The City of Sparks
OVER \$50,000 CHANGE ORDER

CHANGE ORDER NO.: 1
PROPOSED COUNCIL DATE: April 13, 2020

PROJECT/BID NO/PWP NO: 2020 PCC Alley – Bid #19/20-013 – WA-2020-079

Subject: 2020 Sparks Alley Way Project- Storm Drain & Sewer Removal & Replacement

Hymer Alley CO Exhibit

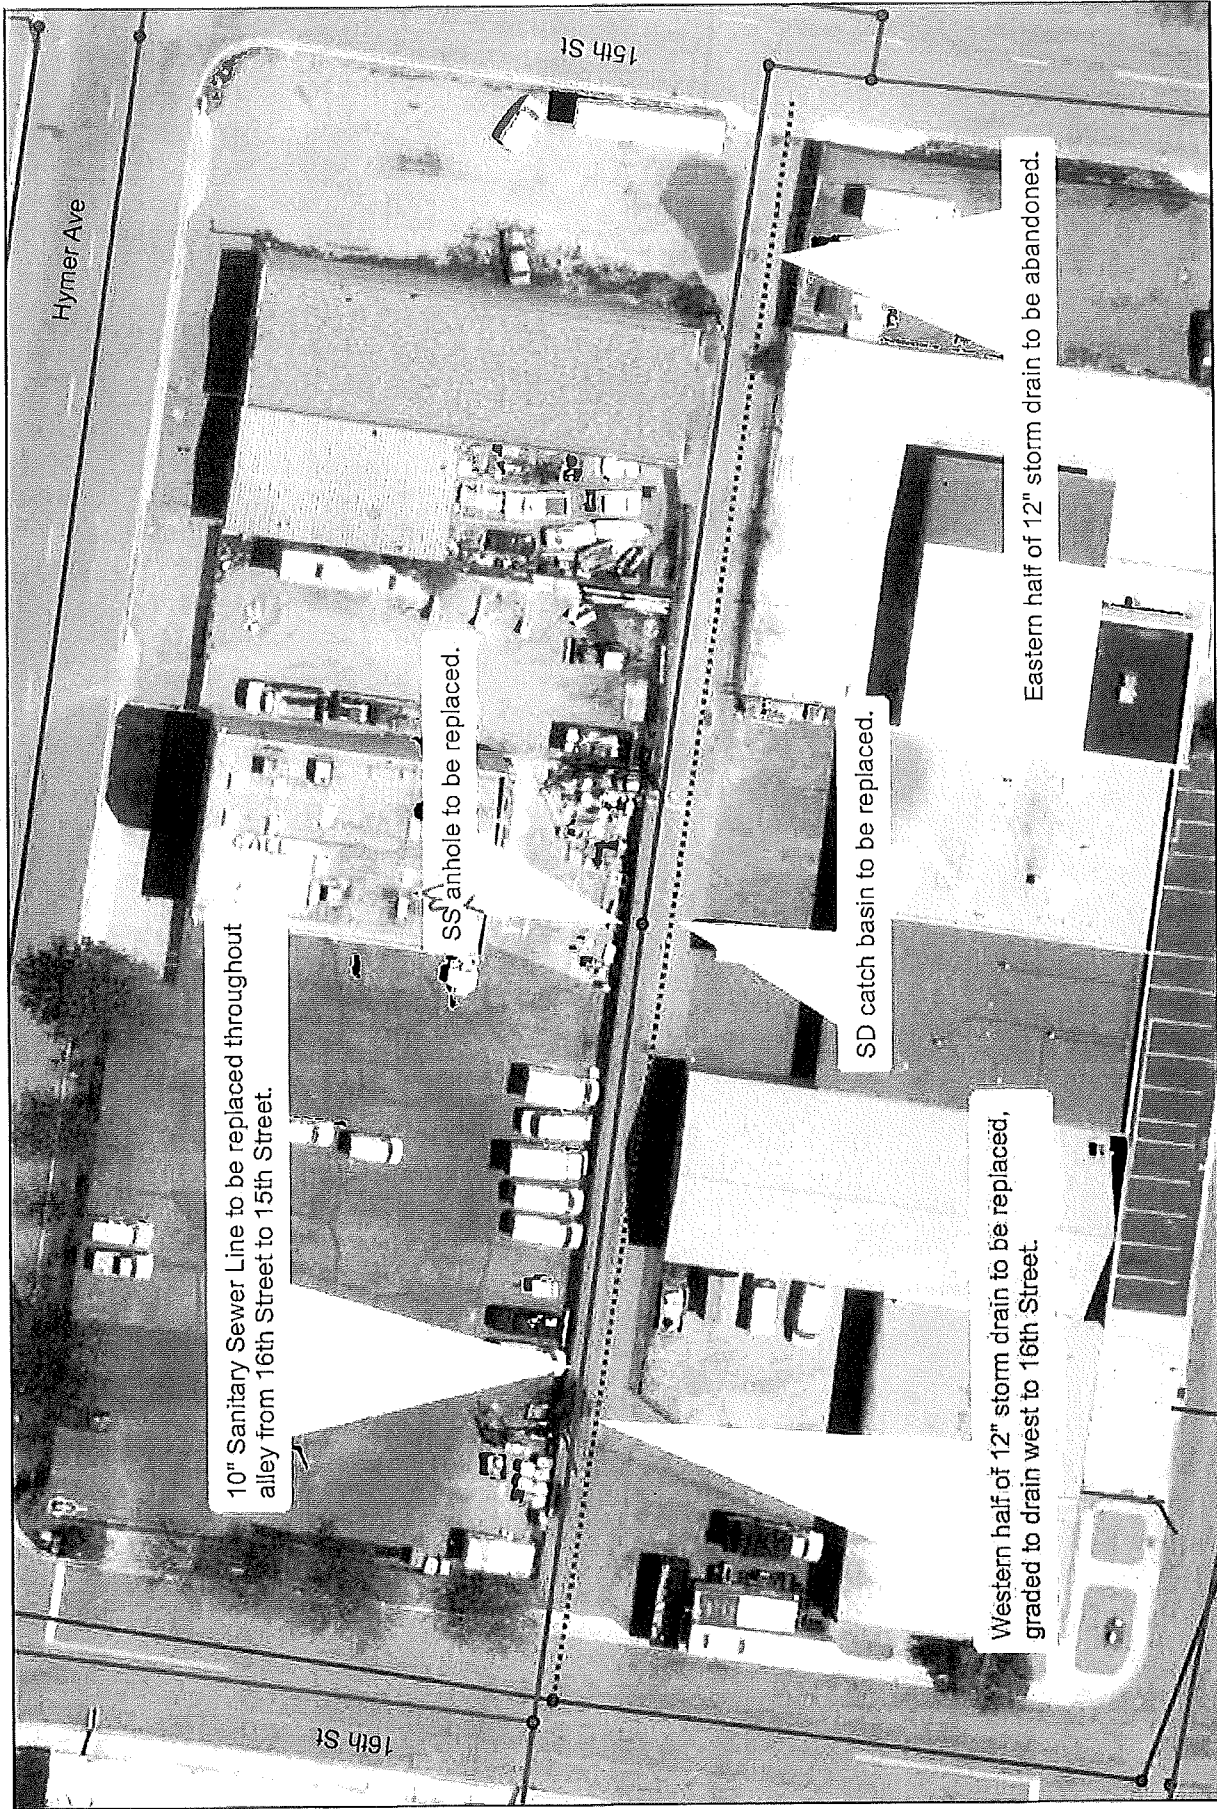
12" Storm Drain Line – During excavation for the surface improvements it was discovered that the existing 12" storm drain line and catch basin in the alley is abandoned at 15th Street. To correct the flow direction, it is proposed to replace the existing catch basin in the alley and set the invert to reverse the flow direction back to the active storm drain line on 16th Street. The not to exceed replacement price from Spanish Springs Construction is \$25,000.

10" Sanitary Sewer Line – The sewer line in the Hymer alley runs from 16th Street to 15th Street. The pre-project inspection did not reveal a need for replacement, however the line is shallow (the invert is approximately 3 ft below grade) and began to collapse during the surface improvement work. Based on the extent of the collapse, the recommended solution is replacement of the 10" line and the mid-point manhole from 16th Street to 15th Street. The not to exceed replacement price from Spanish Springs Construction is \$72,000.

Remove & replace existing 12" URCP with 12" SDR 35 PVC from new catch basin to back of curb of the 16th Street driveway entrance. Price also includes the windrow of new base rock to be reused after work is completed and the partial removal of the PCC commercial driveway. The remainder of the existing storm drain back to 15th Street driveway entrance to either be left as is or can be crushed and left in place. There was also some standby time that we had while waiting for the outcome that will be included in the final price. Spanish Springs Construction will complete this work for the T&M price not to exceed \$25,000.00

Remove & replace existing 10" URCP with 10" SDR 35 PVC pipe between 16th Street and 15th Street the entire distance of the alley project, remove & replace the 4" sewer services from the main to outside of the new PCC Concrete Alley. Price also includes additional removal of the new aggregate base including replacing the stabilization fabric, additional demo & replacement of the PCC driveways, bypass pumping of the sewer while installing the new pipe. Spanish Springs Construction will complete this work for the T&M price not to exceed \$72,000.00.
